MEMORANDUM

RE: INFORMATION FOR MAY 16, 2006 WORKING SESSION

PETITION #102-06(2) AND PETITION #102-06(03) - LAGRANGE STREET

Re: Special Permit — Kessler Woods Condominiums

FIGURE 1

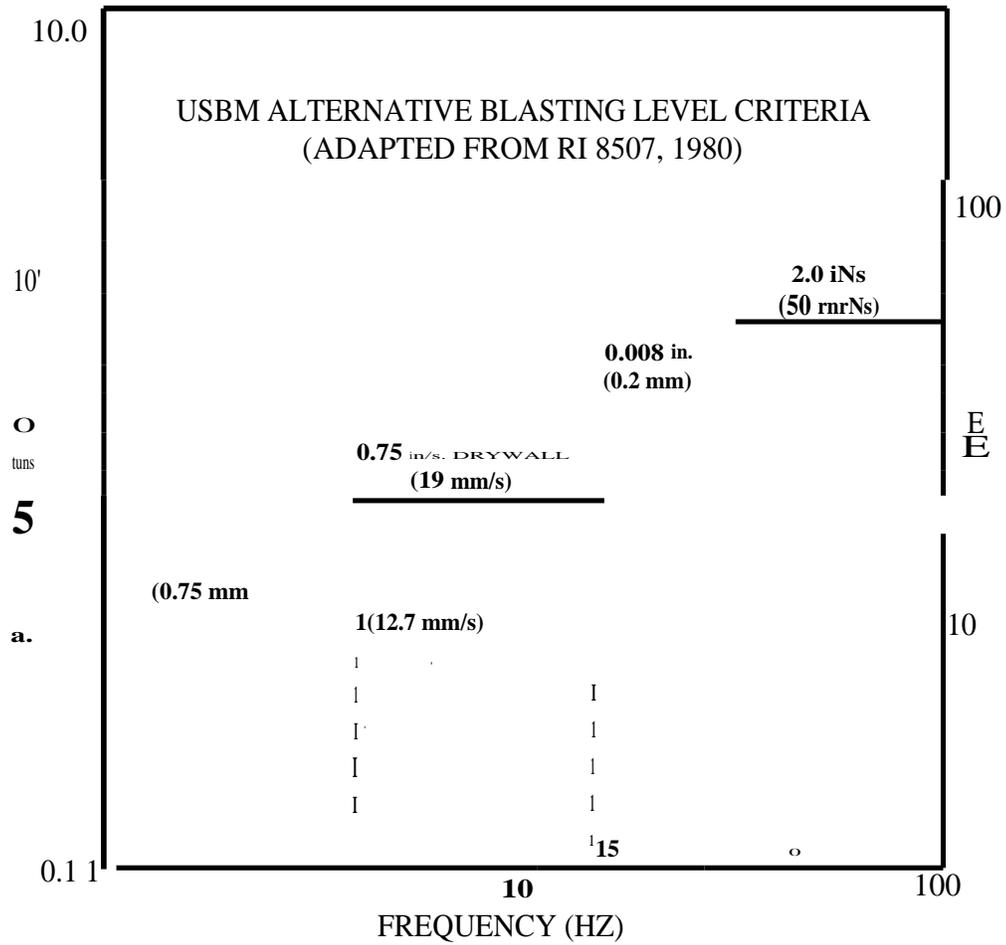
It is recommended that the ground vibrations at adjacent structures be kept below the safe limits recommended by the U.S. Bureau of Mines (USBM RI 8507, 1980), which are provided on Figure 1, and are consistent with the Massachusetts regulations controlling blasting (527 CMR 13.00). These limits are based on the, frequency and the peak particle velocity of the blast vibrations, and are safe limits for preventing cosmetic damage to residential structures.

1. Maximum blast induced ground vibrations at the nearest adjacent above ground structure to blasting should be kept below the U.S. Bureau of Mines recommended Safe Limits, as indicated on Figure 1.
